Agenda Item # 2

SUB-003223-2025

Oak Bend Estate Subdivision

OAK BEND ESTATE SUBDIVISION

DETAIL SITE PLAN

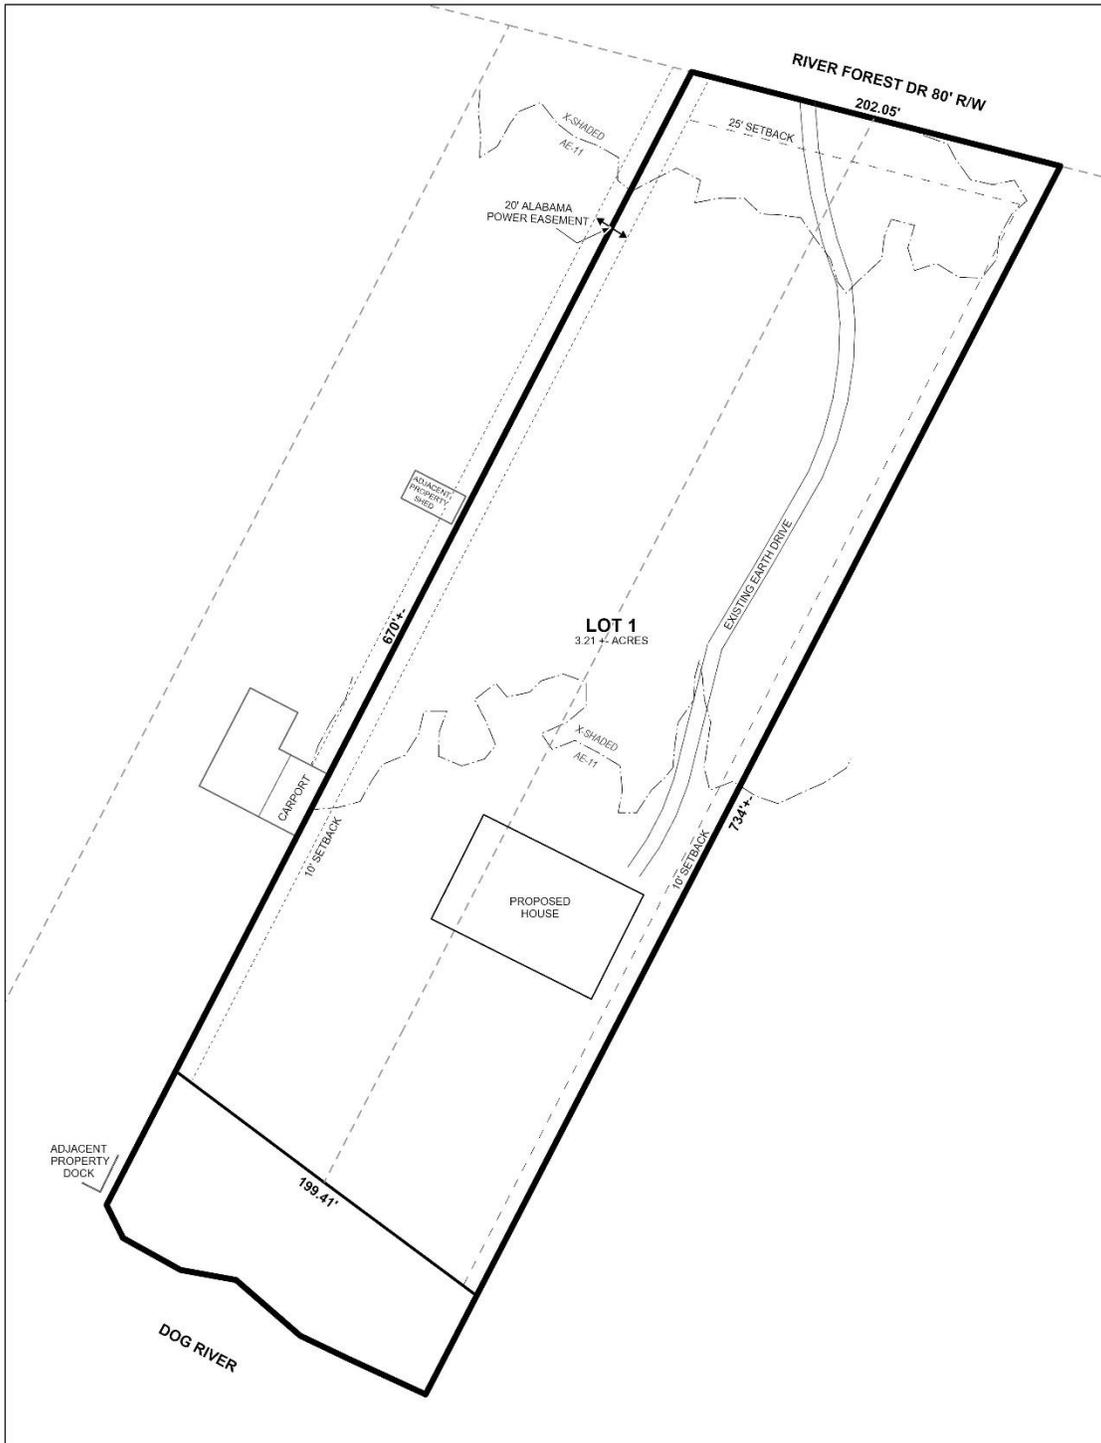
The site has frontage along River Forest Drive, a minor street without curb and gutter with an 80-foot wide right-of-way; therefore, no additional dedication should be required. As on the preliminary plat, the right-of-way width of River Forest Drive should be retained on the Final Plat, if approved. The 25-foot minimum front yard setback line should also be retained on the Final Plat, if approved. The 10-foot side yard setback lines should be removed from the Final Plat.

The lot size exceeds the minimum size requirements of the Subdivision Regulations for lots served by public water and sanitary sewer in an R-1 Suburban District and, if approved, the lot size label in both square feet and acres should be retained on the Final Plat; or a table should be furnished on the Final Plat providing the same information.

The proposed lot exceeds the maximum depth limits of Section 6.C.3. of the Subdivision Regulations. However, as such lots are typical of the area, a waiver of that section may seem appropriate.

The site shares a 20-foot Alabama Power Company easement with the adjacent site to the West. Therefore, a note should be required on the Final Plat, if approved, stating that no structure may be placed or constructed within any easement without the permission of the easement holder.

1. Retention of the 80-foot right-of-way width of River Forest Drive on the Final Plat;
2. Retention of the 25-foot minimum front yard setback line along River Forest Drive on the Final Plat;
3. Removal of the side yard setback lines from the Final Plat;
4. Retention of the lot size label in both square feet and acres, or the furnishing of a table on the Final Plat providing the same information;
5. Placement of a note on the Final Plat stating that no structure may be constructed or placed within any easement without the permission of the easement holder;
6. Compliance with all Engineering comments noted in this staff report;
7. Placement of a note on the Final Plat stating all Traffic Engineering comments noted in this staff report;
8. Compliance with all Urban Forestry comments noted in this staff report; and,
9. Compliance with all Fire Department comments noted in this staff report.
